Well Name: BIG EDDY UNIT 30E SKYWALKER	Well Location: T20S / R31E / SEC 14 / NWSW / 32.570286 / -103.847043	County or Parish/State: EDDY / NM
Well Number: 101H	Type of Well: OIL WELL	Allottee or Tribe Name:
Lease Number: NMLC0063667, NMLC063667	Unit or CA Name: BIG EDDY	Unit or CA Number: NMNM68294X
US Well Number: 3001546195	Well Status: Approved Application for Permit to Drill	Operator: XTO PERMIAN OPERATING LLC

Sundry ID: 2713481

Type of Submission: Notice of Intent **Type of Action:** APD Change

Procedure Description: **Casing & Cement Changes XTO Permian Operating, LLC requests permission to make the following changes to the original APD: Casing and cement changes due to US supply chain issues. Updated drilling program is attached. Attachments: Drilling Program MBS Diagram

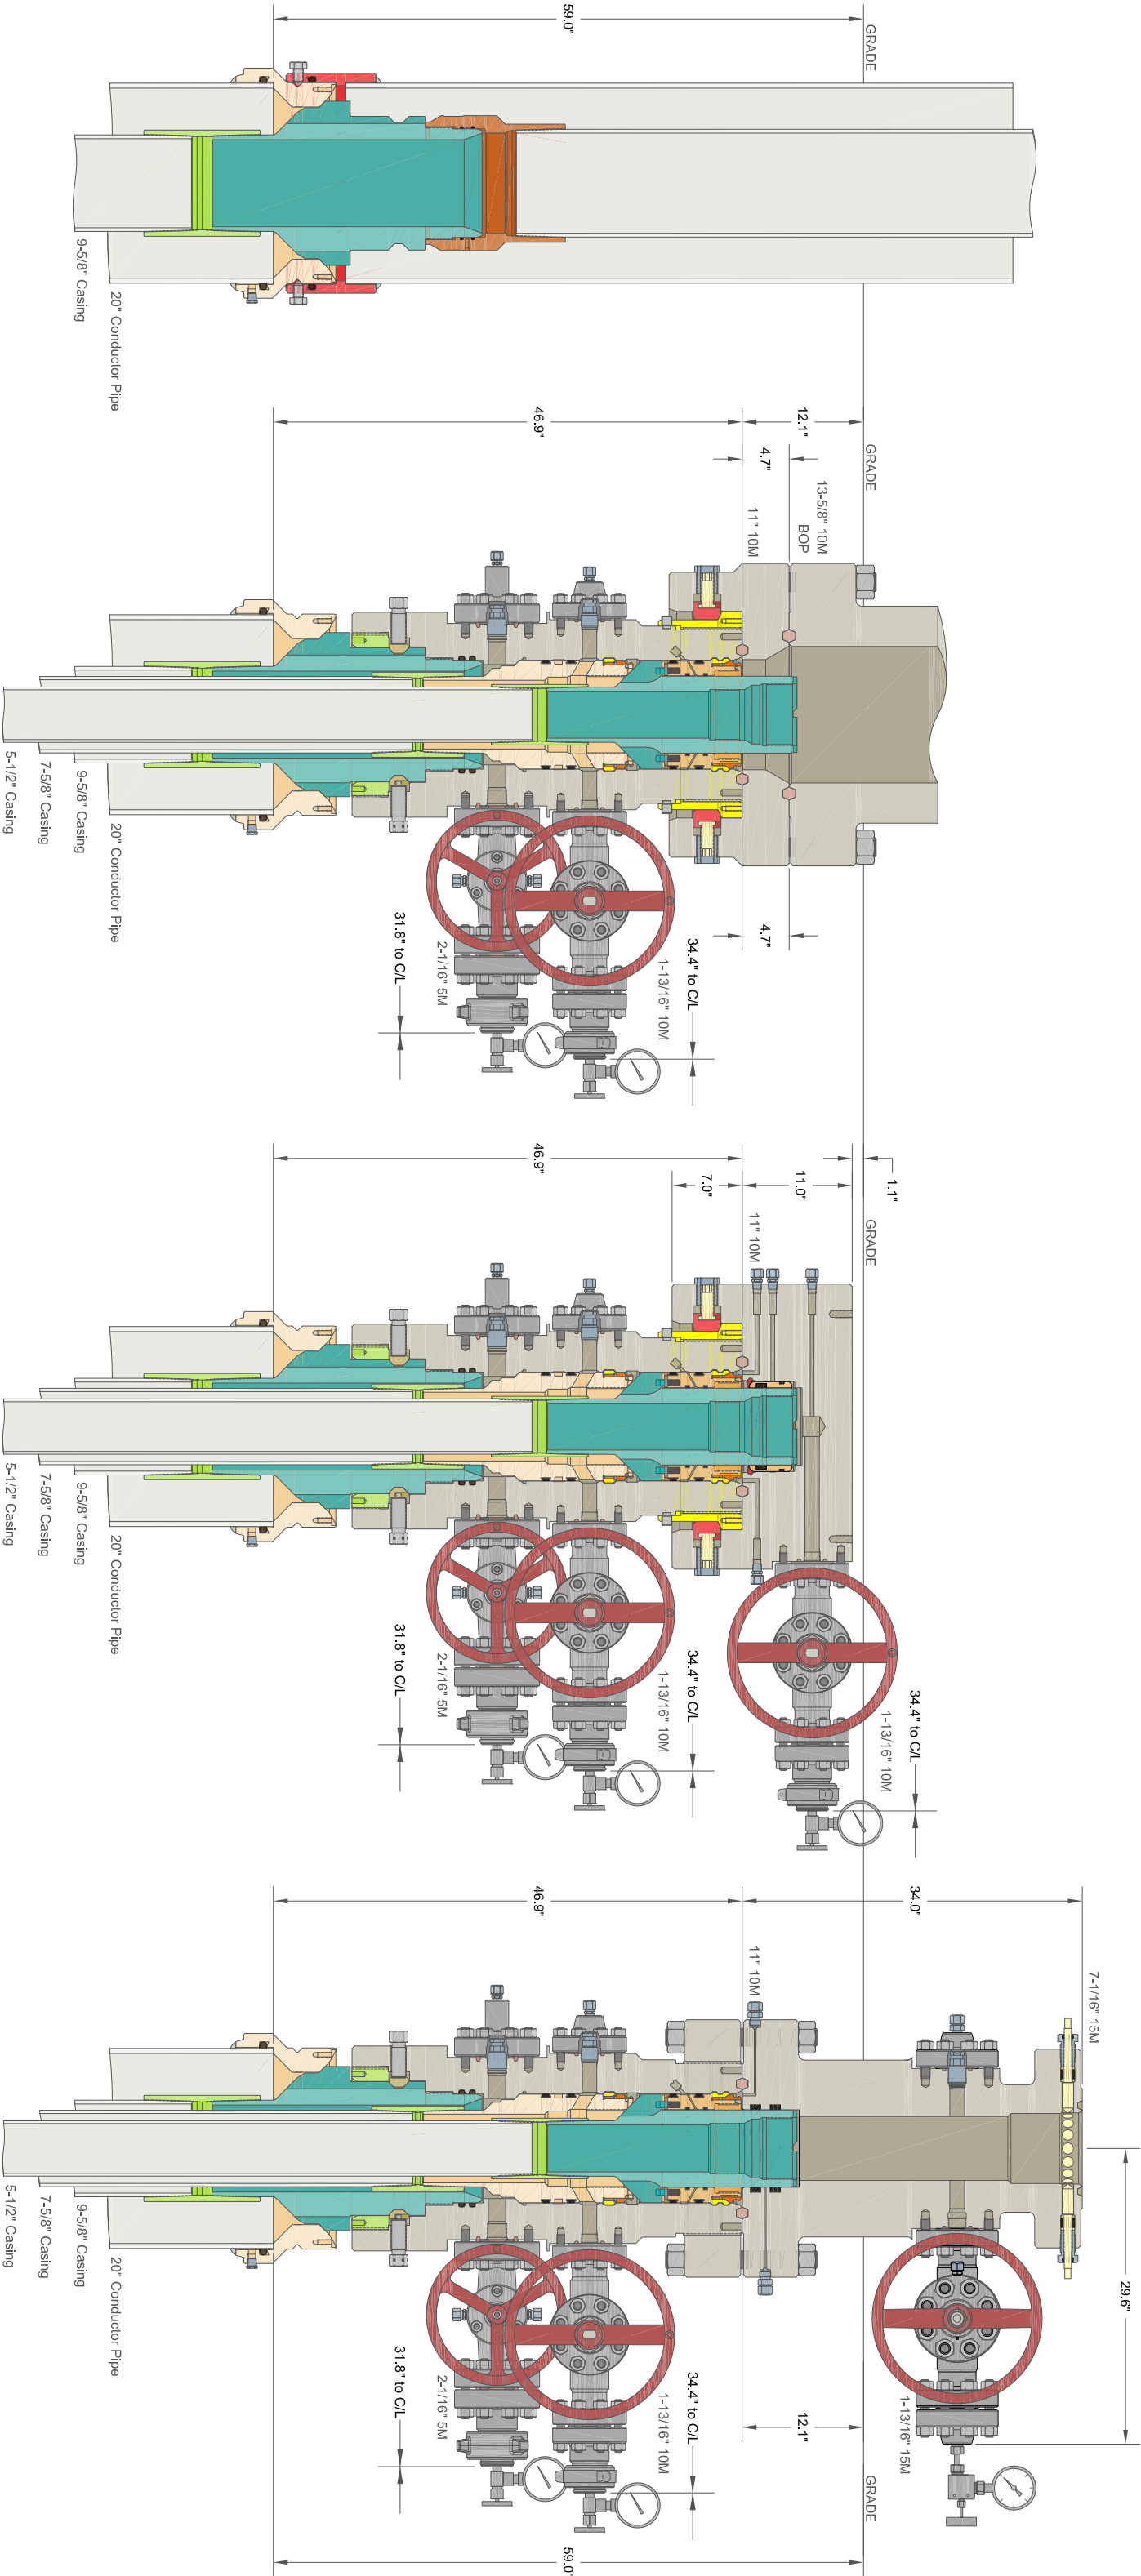
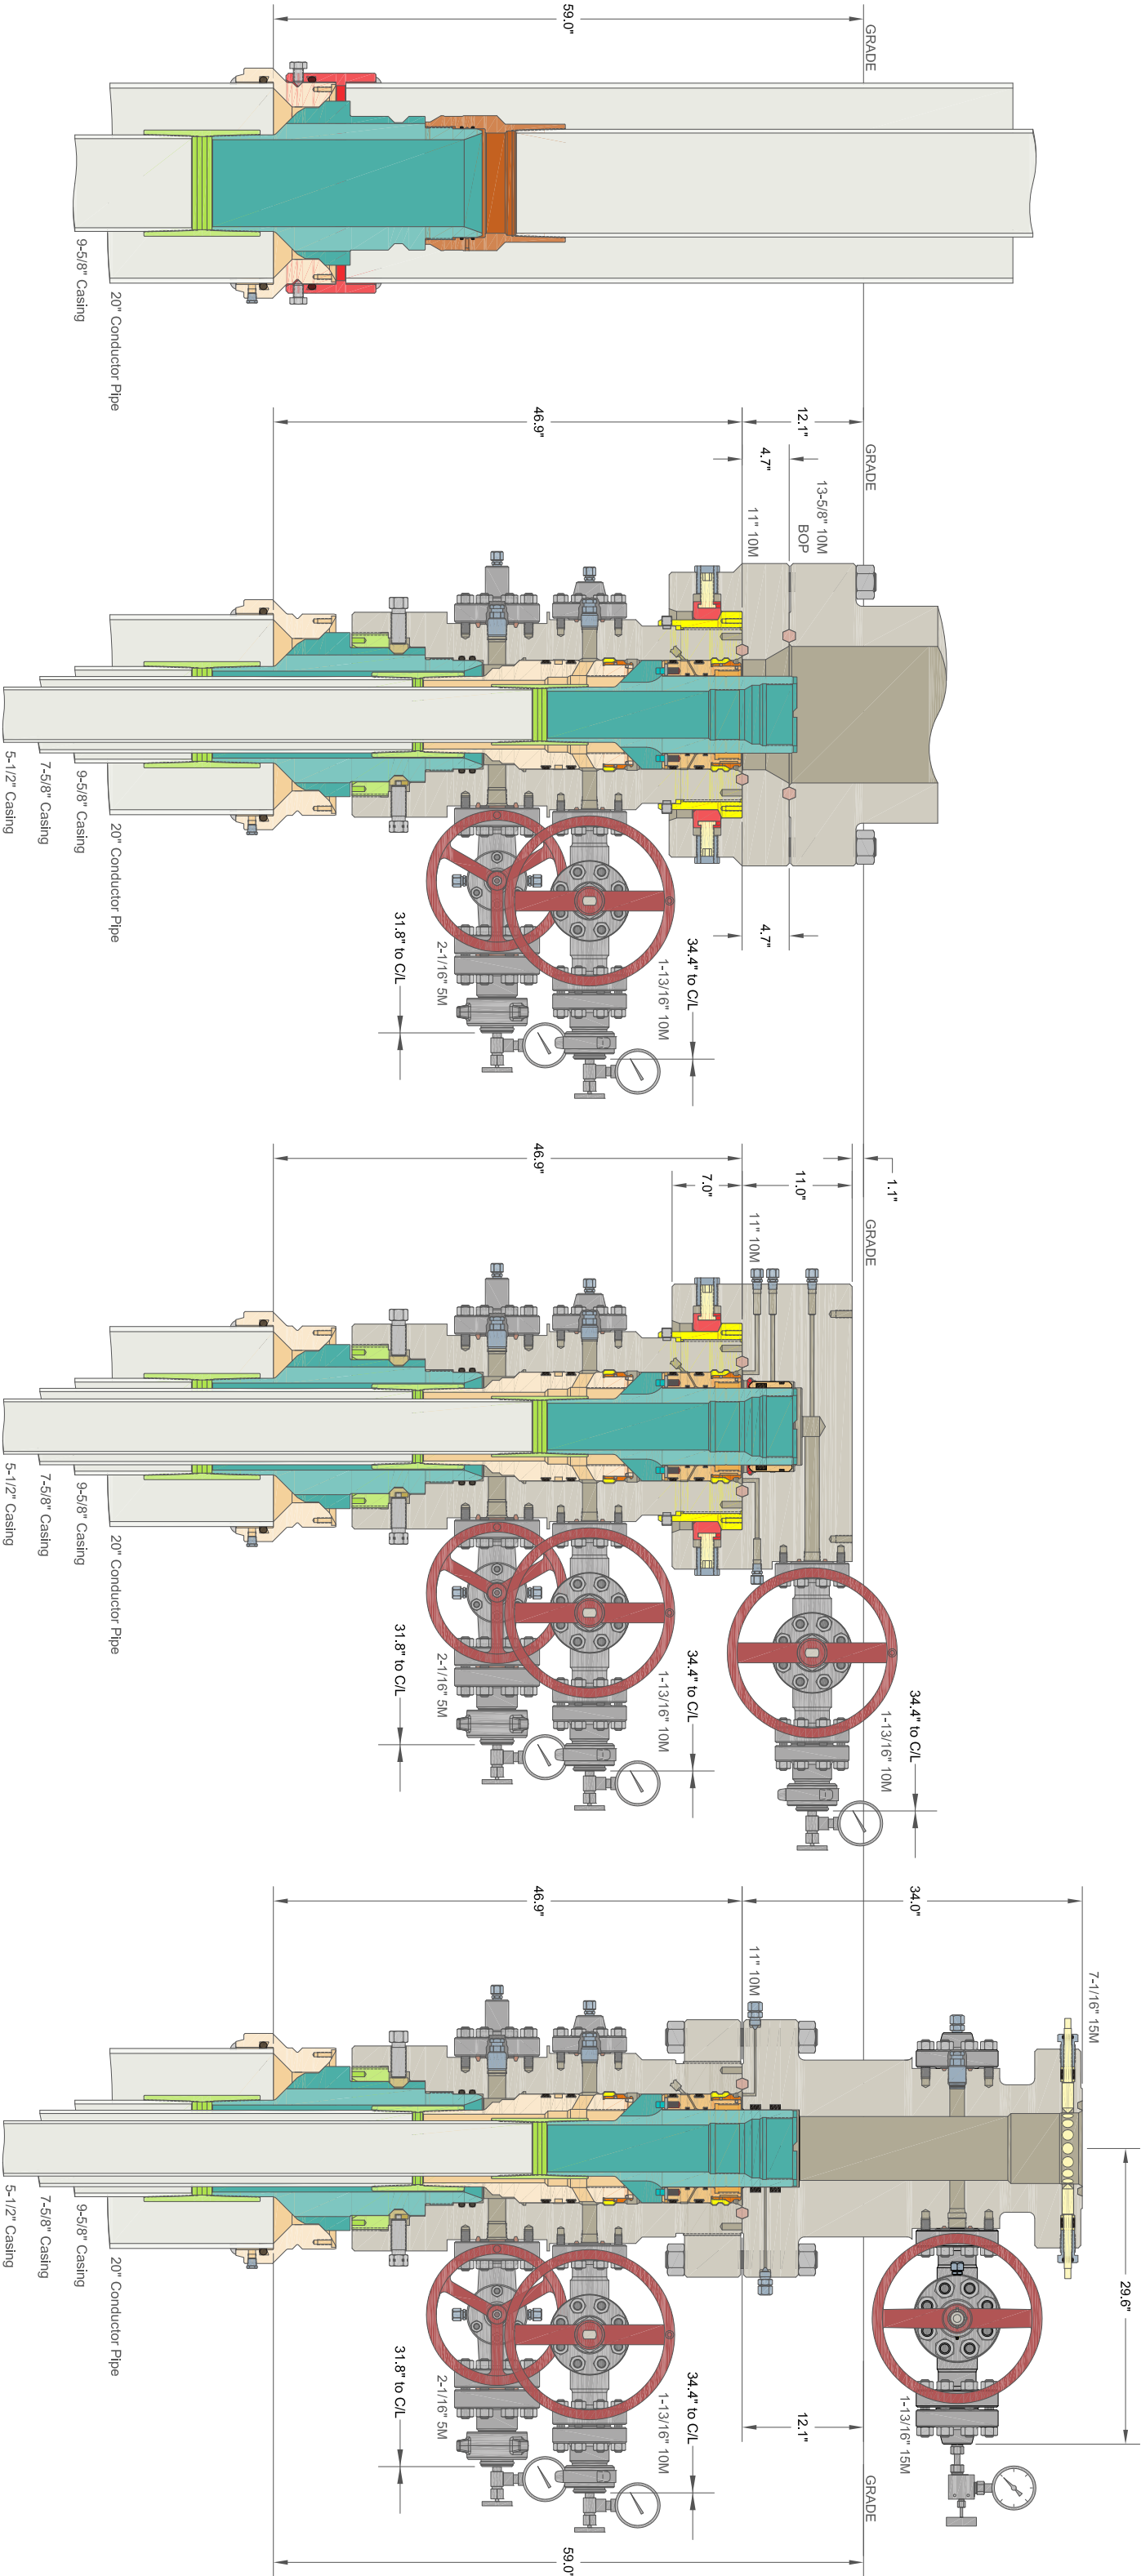
Permanent Wellhead – Multibowl System

A. Starting Head: 13-5/8" 10M top flange x 13-3/8" bottom

B. Tubing Head: 13-5/8" 10M bottom flange x 7-1/16" 15M top flange

- Wellhead will be installed by manufacturer's representatives.
- Manufacturer will monitor welding process to ensure appropriate temperature of seal.
- Operator will test the 9-5/8" casing per BLM Onshore Order 2
- Wellhead Manufacturer representative will not be present for BOP test plug installation

1. Variance approved to use flex line from BOP to choke manifold. Manufacturer's specification to be readily available. No external damage to flex line. Flex line to be installed as straight as possible (no hard bends).'
2. Operator has proposed a multi-bowl wellhead assembly. This assembly will only be tested when installed on the surface casing. Minimum working pressure of the blowout preventer (BOP) and related equipment (BOPE) required for drilling below the surface casing shoe shall be **2000 (2M) psi**.
 - a. Wellhead shall be installed by manufacturer's representatives, submit documentation with subsequent sundry.

4. If the operator has proposed a multi-bowl wellhead assembly in the APD. The following requirements must be met:
 - a. Wellhead shall be installed by manufacturer's representatives, submit documentation with subsequent sundry.

- b. If the welding is performed by a third party, the manufacturer's representative shall monitor the temperature to verify that it does not exceed the maximum temperature of the seal.

- c. Manufacturer representative shall install the test plug for the initial BOP test.
 - d. Whenever any seal subject to test pressure is broken, all the tests in OOGO2.III.A.2.i must be followed.

- e. If the cement does not circulate and one inch operations would have been possible with a standard wellhead, the well head shall be cut off, cementing operations performed and another wellhead installed.
